# Kingfisher Pond - Northstowe Hydrogeological Assessment

## Baseline Conceptual Report

FWM8714-RT001-R03-00

## D. Review of Phase 1 Report

Figure 4.3: Map highlighting locations of boreholes of interest at Northstowe Phase 1

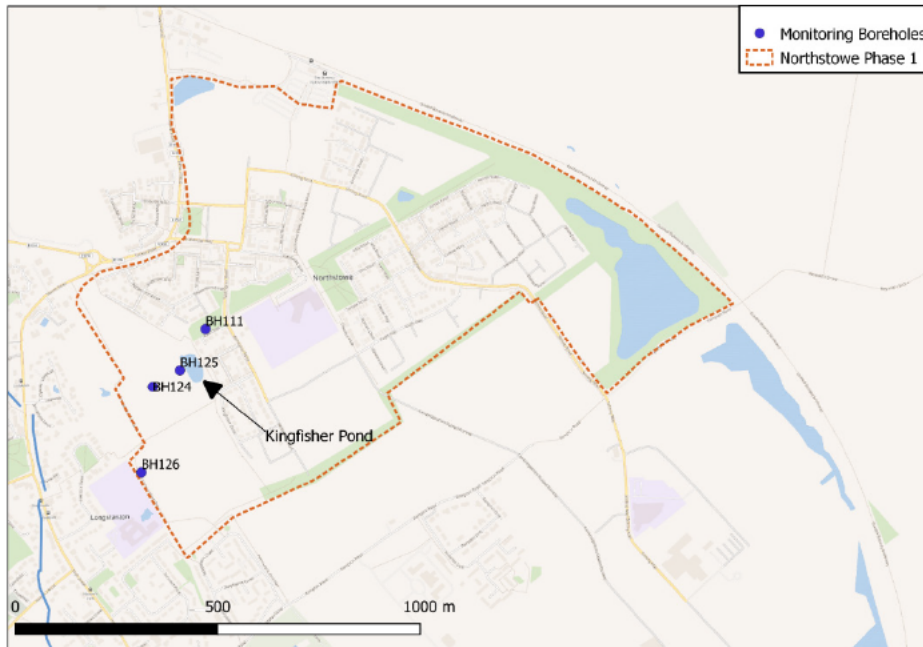
The report mentions boreholes of interest and provides a map showing some boreholes on Phase 1. Due to the known hydraulic connectivity of the RTD (which would have been known prior to planning permission being granted), this report makes no mention of any bore holes being monitored off site elsewhere across Longstanton and the gravels. The report does not make clear whether off site monitoring of the groundwater levels in the RTD was being carried out and whether it was a requirement of the planning permission. With the presence of a multitude of lakes and ponds along the RTD, in addition to the wells, the Listed churches, a Listed Manor House, the entire Longstanton conservation area and trees with Tree Preservation Orders on them – it seems that not making this clear is an oversight. Indeed, should the original planning permission have contained safeguards to protect the ponds, wells, buildings and conservation area from possible damage due to works being carried out on the RTD? I would have thought that there was a statutory obligation on SCDC to monitor Northstowe works and protect Longstanton's Listed buildings, the conservation area and TPO trees from being damaged by the Northstowe development. This clearly is an issue that needs to be addressed in the next report. The hydraulic connectivity of the groundwater in the RTD is the key to understanding why such extensive damage has been recorded across Longstanton. Once again, HR Wallingford cannot be responsible for the limited scope of this report but the limited scope should not restrict discussion on the wider potential impacts of the reduction in the groundwater, and the vulnerabilities and consequences to Longstanton property of a catastrophic collapse.
